PRELIMINARY OVERALL AREA DEVELOPMENT PLAN  
HAUSMAN HILL SUBDIVISION  
SAN ANTONIO, TEXAS

# PRELIMINARY OVERALL AREA DEVELOPMENT PLAN APPLICATION (POADP)

Re: Hausman Hill Subdivision

POADP # 522

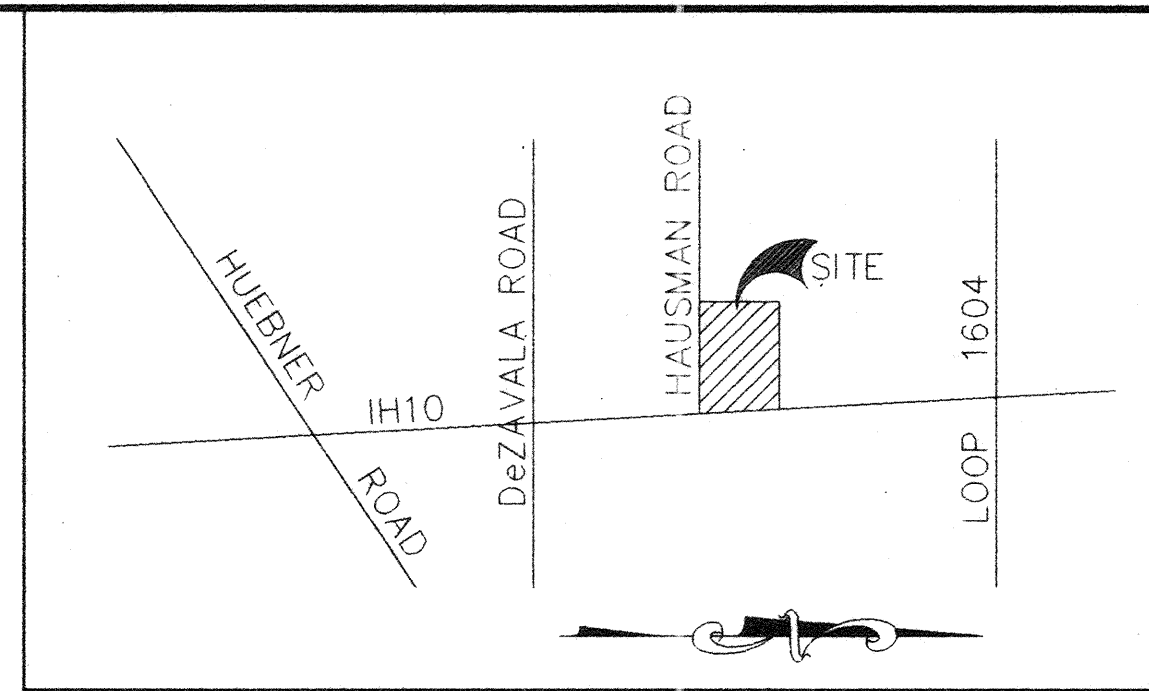
- Access issues along State facilities will need to be resolved with the Texas Department of Transportation (TXDOT). For additional information about these requirements you can contact TXDOT at 615-5814.
- Based on the topography, a Flood Plain Study and drainage review will probably be required during the platting process.

Also, please be aware that this section of Hausman Road does not appear on the Major Thoroughfare plan.

Comments: DRAINAGE EASEMENTS WILL BE  
REQUIRED AND ADDRESS DURING  
PLATTING

- remove Hausman Rd from POADP.

- note road is not labeled correctly

\* TXDOT should object shared access point (not allowed three access points.
